CITY OF BERKLEY, MICHIGAN REGULAR MEETING OF THE CITY PLANNING COMMISSION

1. **AMENDMENT TO PLANNED UNIT DEVELOPMENT PPUD-01-25: The Columbia:** The applicant, Krieger Klatt Architects on behalf of WJ Ventures LLC, 2465 Columbia, 2475 Columbia, 2468 Columbia and 2476 Columbia and 2475 Cambridge, is requesting an amendment to the Planned Unit Development previously approved for a multiple-family development on the east side of Coolidge Highway, south of Cambridge Road and north and south of Columbia Road
2. **Planning Commission Liaison for Chamber of Commerce**

The applicant has submitted an amendment to the approved Planned Unit Development for The Columbia. The project history is detailed in the Community Development Department review memo.

Thank you for the review of PUD Amendment for "The Columbia" project dated "02.13.2025 Revised PUD". Below are responses to your March 3, 2025 review letter. All responses will be cross referenced with revised documents dated "03.13.2025 Revised PUD - Rev. #1".

Sheet Title: _____
Carport Elevations

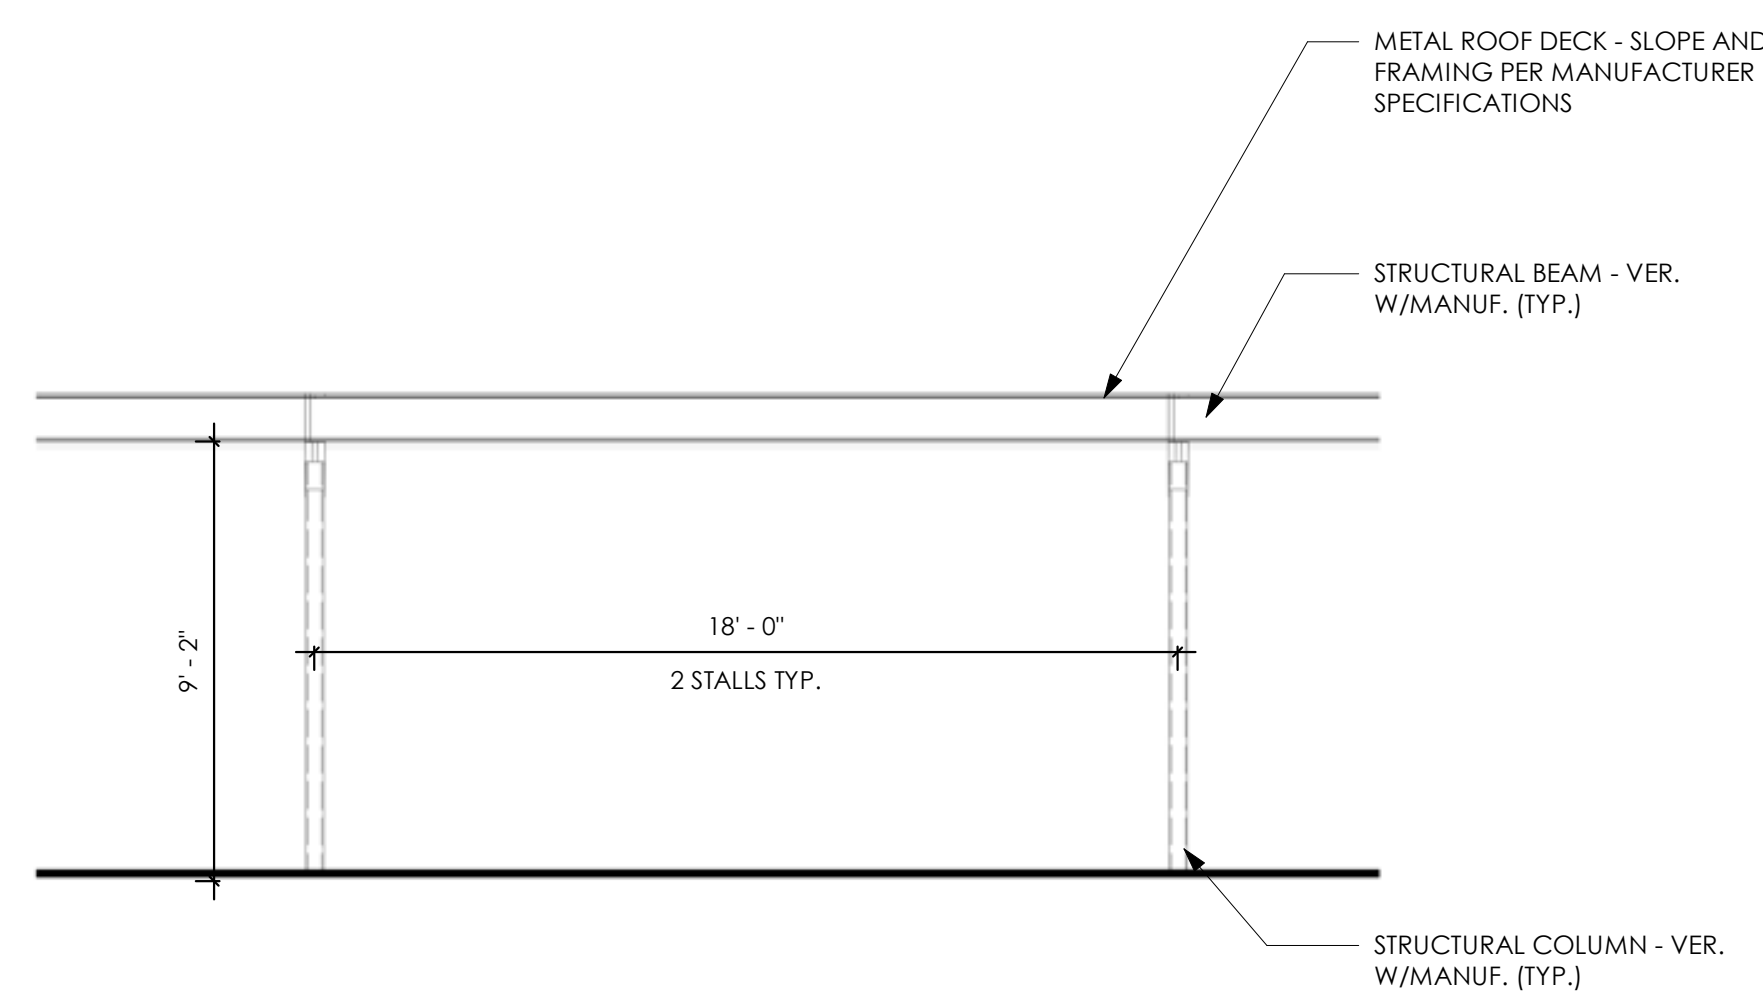
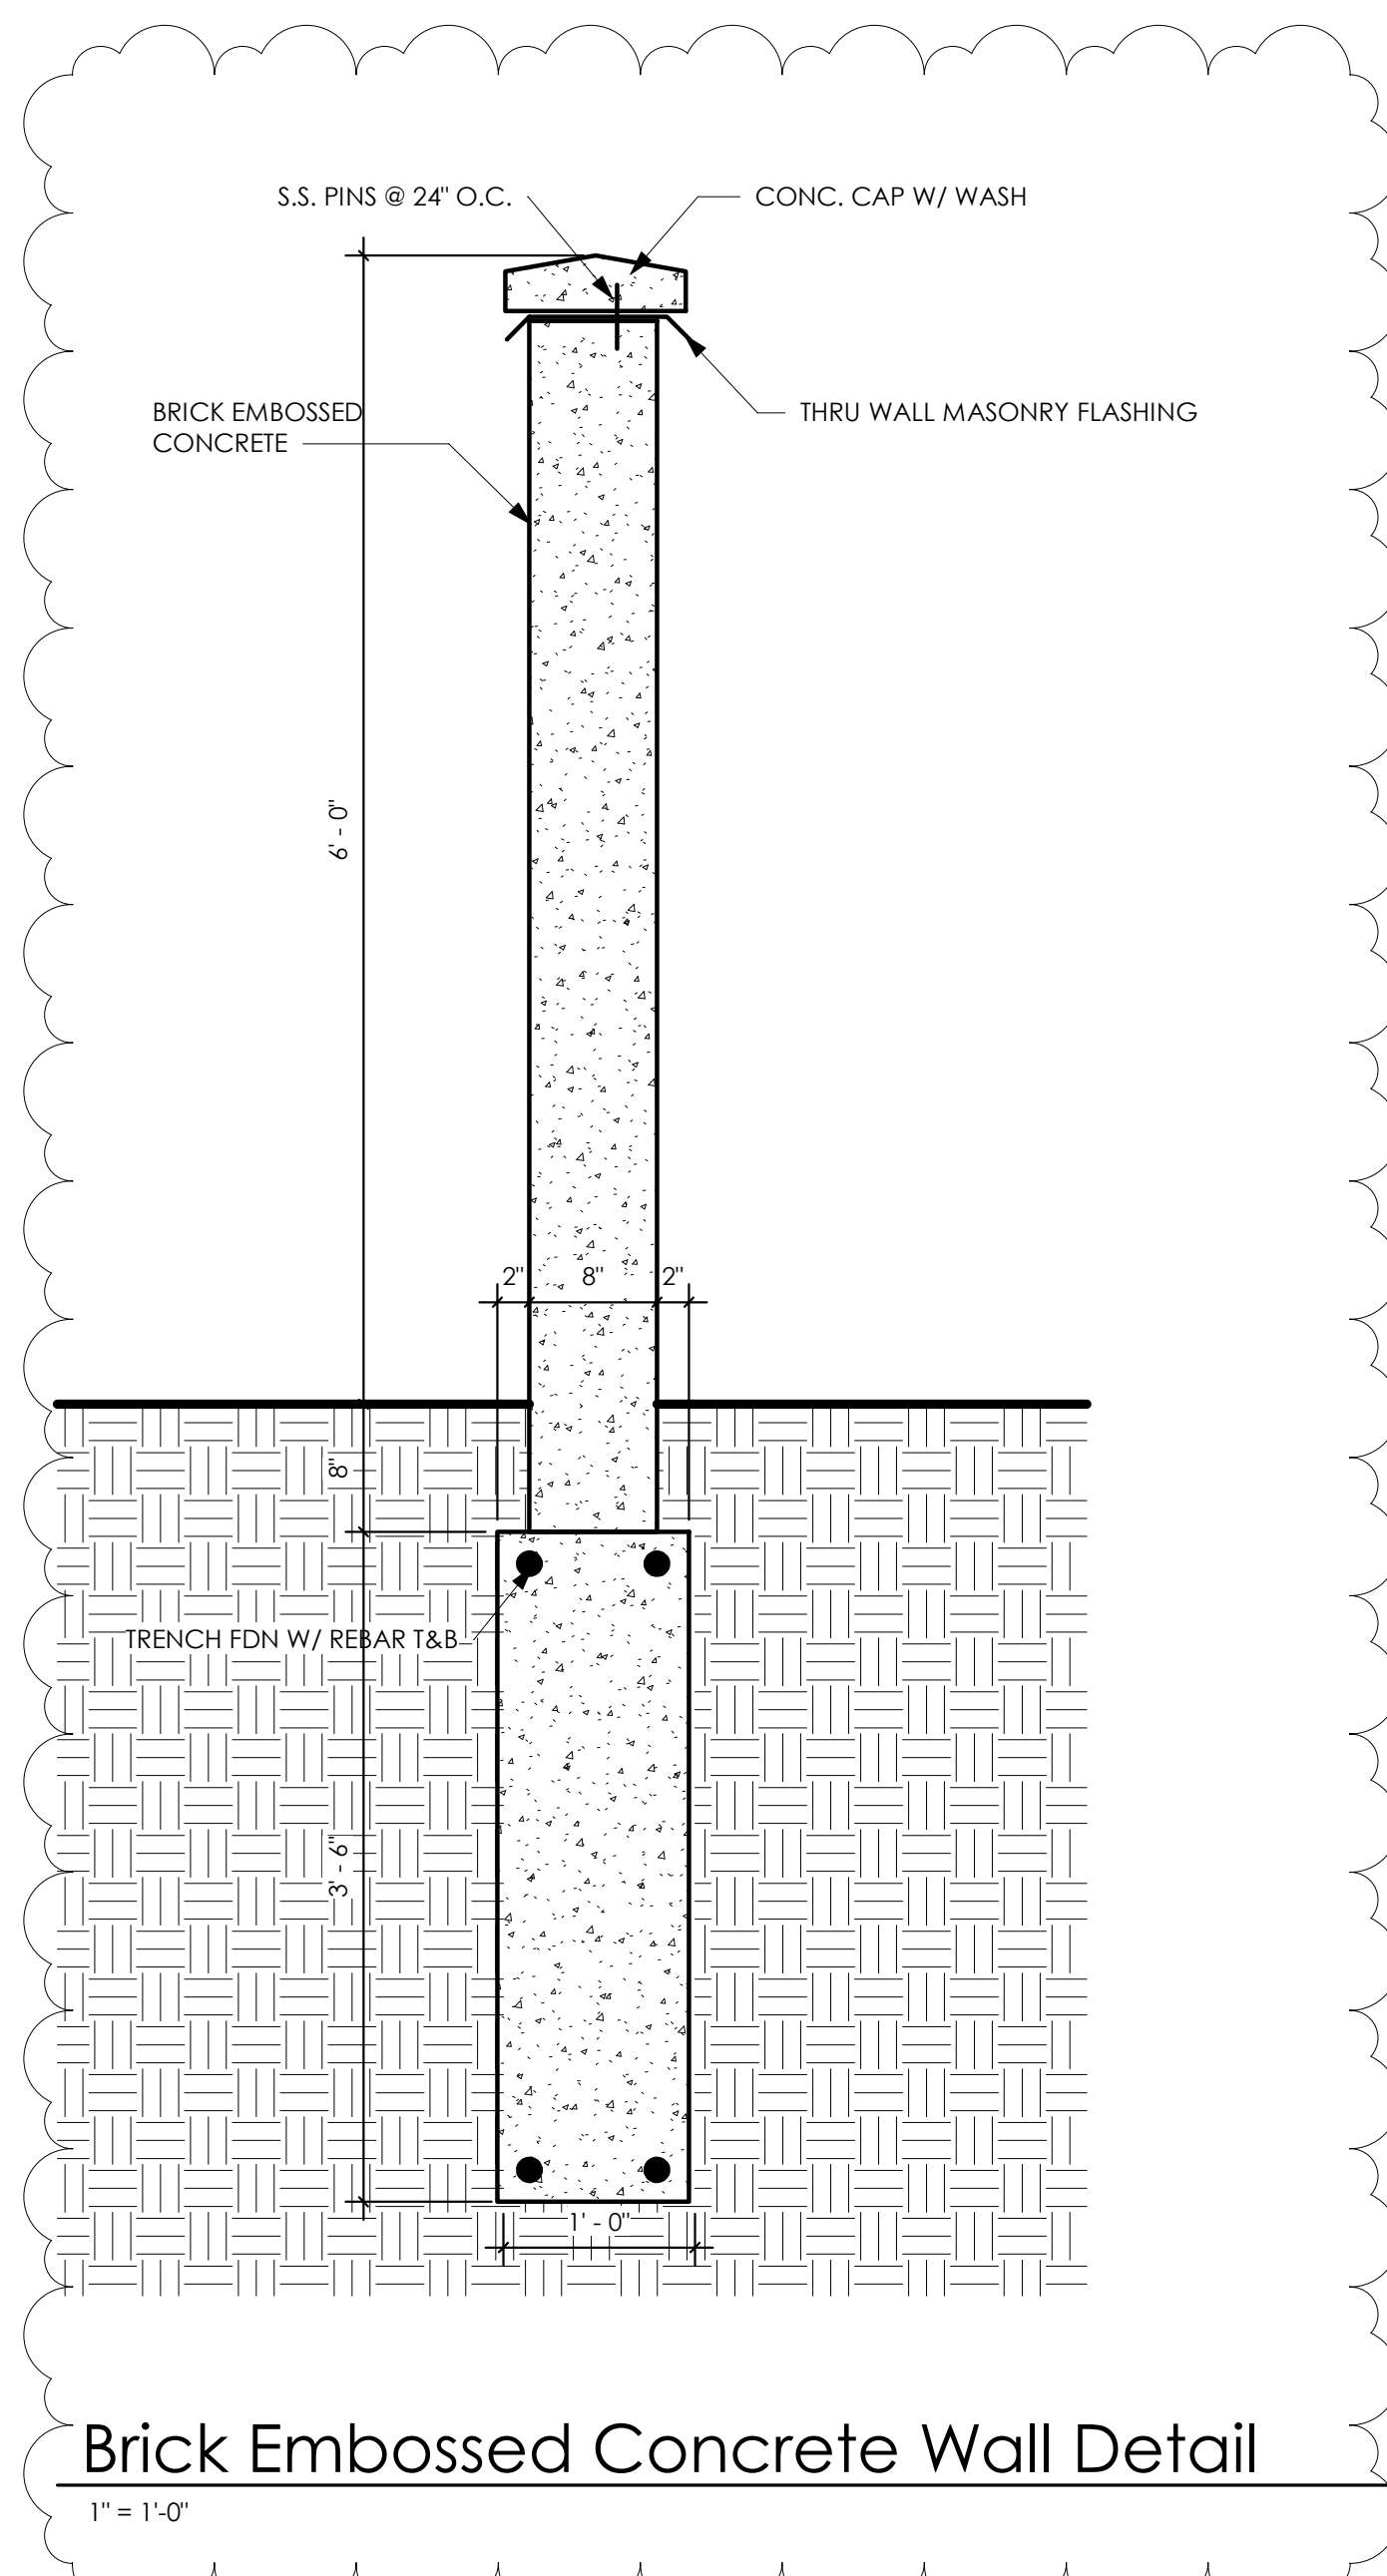
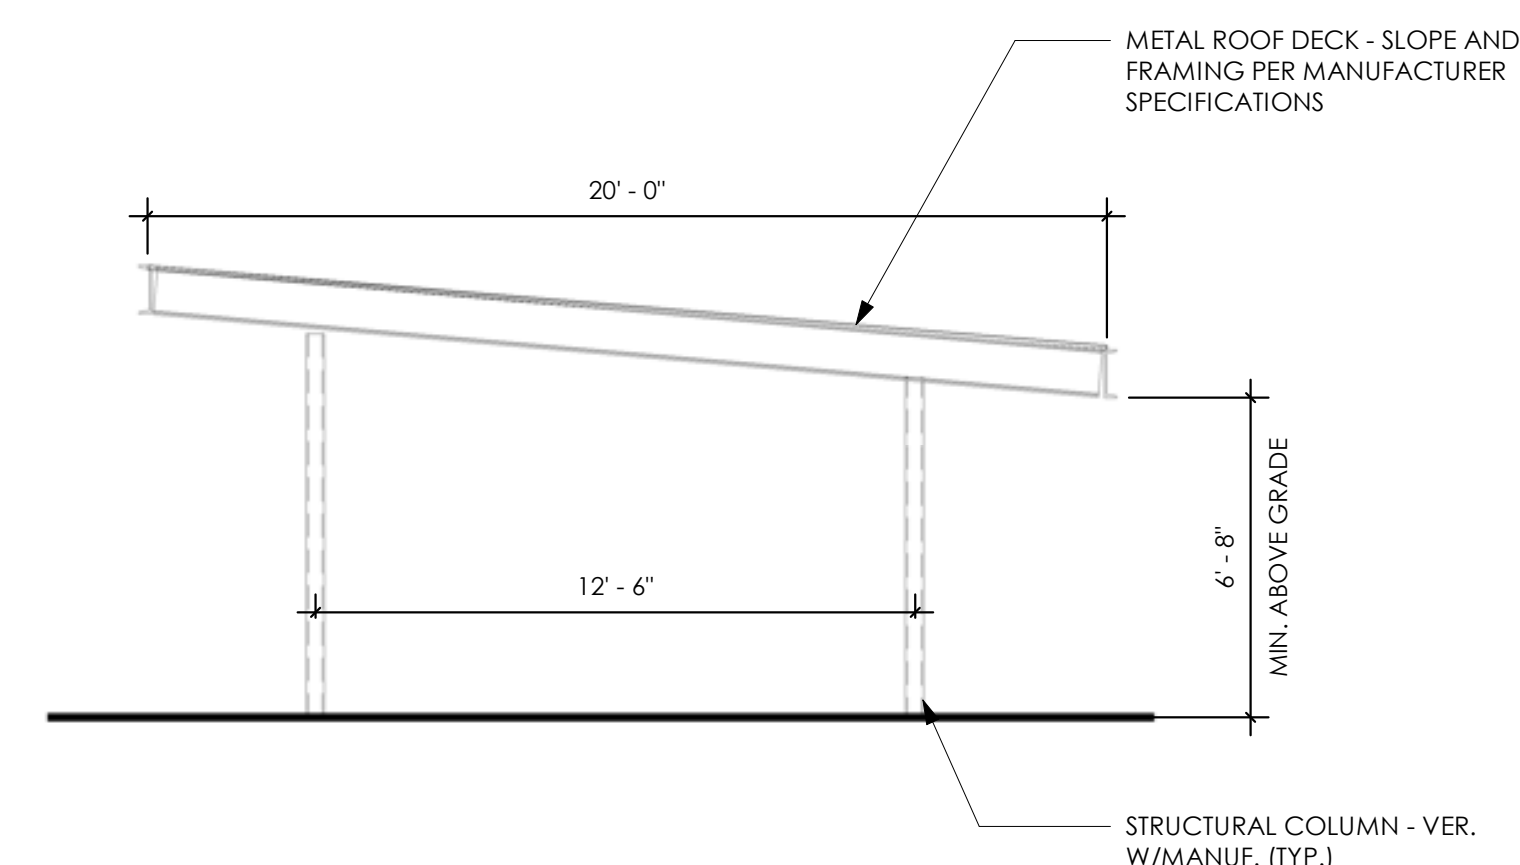
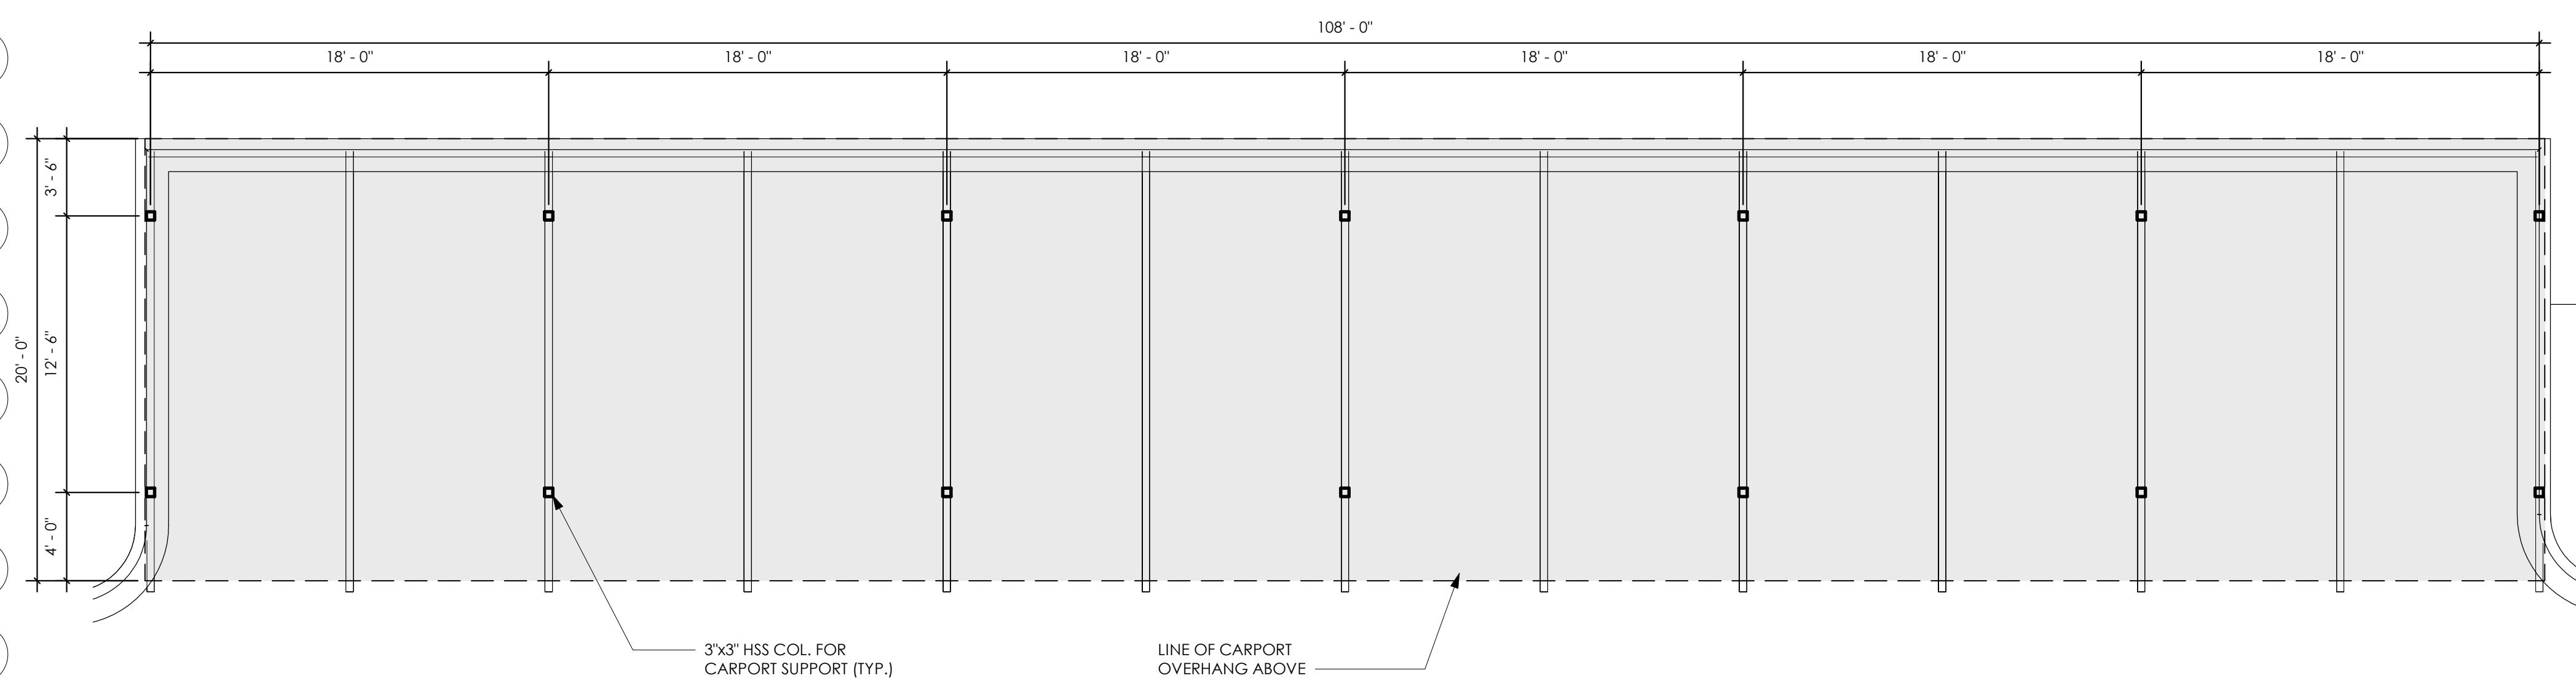
- b. The Southern parcel now contains a surface parking lot with carports (sheet **A.202**) and a pocket park on Coolidge. The pocket park contains seating areas at the Cambridge/Coolidge corner with a large landscaping area to screen the parking area from Coolidge and the neighbors to the east.

- a. Please see the detail added to sheet **A.202** for the screenwall.
3. A photometric plan complying with ordinance standards must be provided prior to the Planning Commission meeting.
